APPLICATION NO.	FILING DATE	FIRST NAMED INVENTOR	ATTORNEY DOCKET NO.	CONFIRMATION NO.
10/588,006	09/20/2006	Quentin Baillia-Prel	0579-1128	1367
466 7590 07/15/2010 YOUNG & THOMPSON 209 Madison Street Suite 500 Alexandria, VA 22314			EXAMINER LUGO, CARLOS	
			ART UNIT 3673	PAPER NUMBER
			NOTIFICATION DATE 07/15/2010	DELIVERY MODE ELECTRONIC

Office Action Summary

DETAILED ACTION

Attachment #1

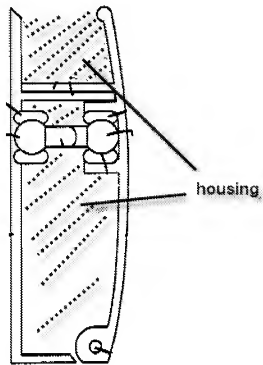
As clearly described and illustrated, the crash bar (4) has a main body, an upper portion or first arm extending from one end and a lower portion or second arm extending from the opposite end, a stop portion extending from the other end of the upper portion and an articulated member (bead) extending from the other end of the lower portion (attachment #1). A broad interpretation will be given to the claim language. Correction is required.

Instead of complicating the claim language with indefinite terms, the applicant is required to use the same terminology used in the specification (see 112 section for a clean and simple interpretation of the crash bar, attachment #1).
